MEMORANDUM

SUBJECT:

FOUNDATION INVESTIGATION REPORT
For

Proposed Structure at the Crossing
of the South Nation River and
Hwy. #43 (Rev'n. Line 'L')
Chesterville Village, Winchester Twp.
District No. 9 (Ottawa)
W.J. 69-F-51 -- W.P. 148-66-01

FOUNDATION LAYOUT
(FOOTINGS & PILE LAYOUT SIMILAR FOR BOTH ABUTMENTS.)
SCALE: 3/8" = 1'-0"

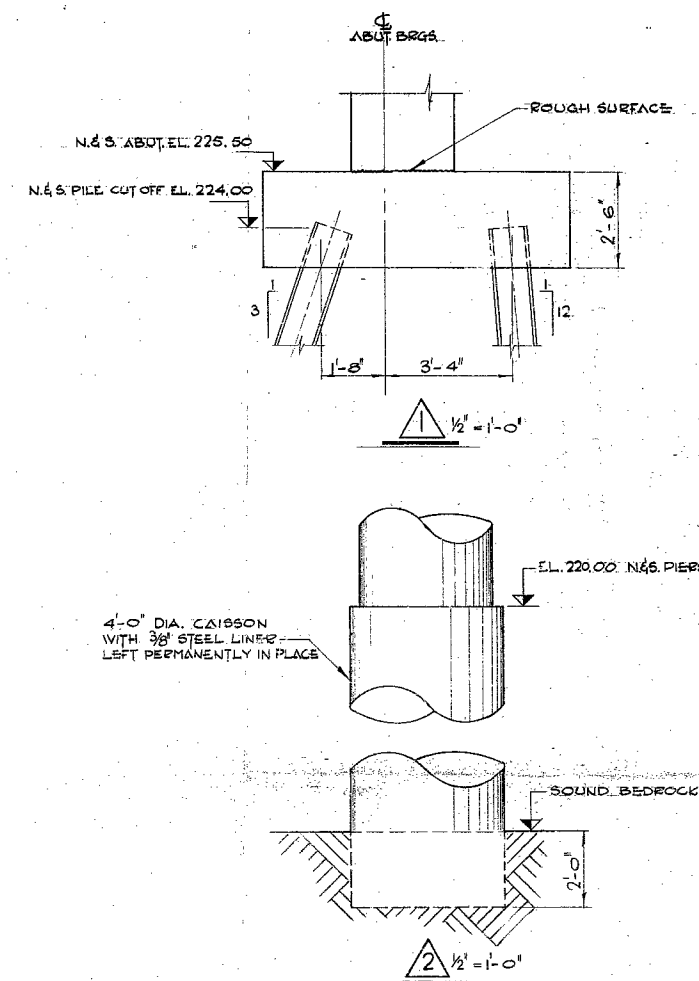
Attached herewith we are submitting the final
bridge drawings which show the foundation design for
this structure.

Kindly give us your comments at your earliest
convenience.

No comments

NOTE ^(estimated) The pile lengths at the
abutment locations are
reasonable.

ii) the Piers - founded on
4' dia. caissons - approx. 35' in
length - i.e. extend 2' to 3' into
sound bedrock - through the fractured
zone
